Applicant:	Bruce et al.	Examiner:	Mohamed, C.
Serial No.:	09/586,518	Group Art Unit:	2857
Filed:	June 2, 2000	Docket No.:	AMDA.455PA
Title:	RESISTIVITY ANALYSIS

OFFICE ACTION RESPONSE AND AMENDMENT

Fig. 1

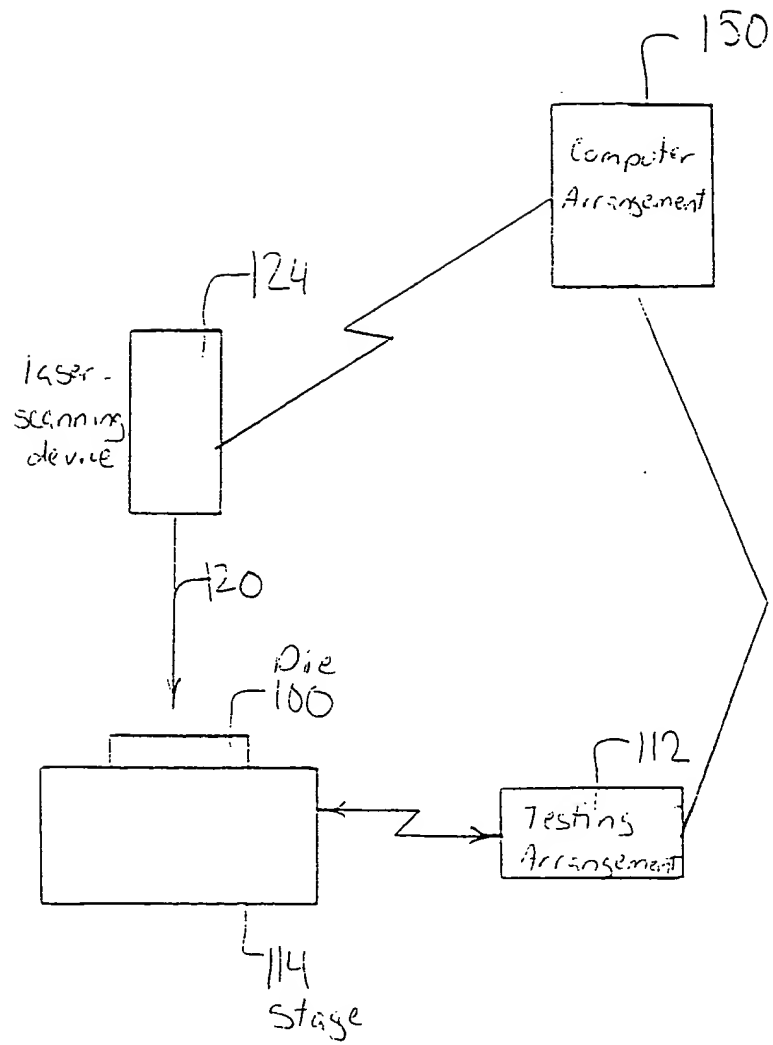
Enclosed please find a replacement drawing sheet for Fig. 1 including labels for each box in red ink.

With respect to the drawing objection, Applicant has enclosed one sheet of proposed drawing corrections including labels written in red ink for each box of Figure 1.
